UNITED STATES PATENT AND TRADEMARK OFFICE

| APPLICATION NO. | FILING DATE | FIRST NAMED INVENTOR | ATTORNEY DOCKET NO. | CONFIRMATION NO. |
|--|-------------|----------------------|---------------------|------------------|
| 09/997,532 | 11/29/2001 | SHAWN R. GETTEMY | PALM-3698 | 5478 |

| Office Action Summary | Application No. | Applicant(s) | |

figure 8 :

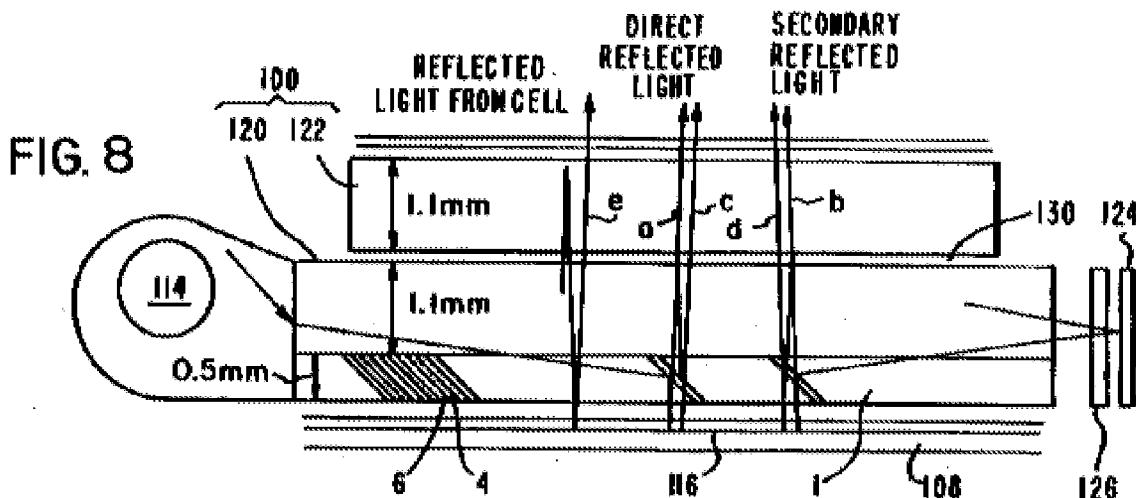
Applicants' first argument that Mamiya's teachings should be limited to reflective-type display is not persuasive because Mamiya also teaches reflective-type display e.g.

Further Mamiya figs. ,col. 7 lines35-40 and col. 10 line 35, etc. describe reflective display comprising pixels and light conducting spacers are shown in AAPR.
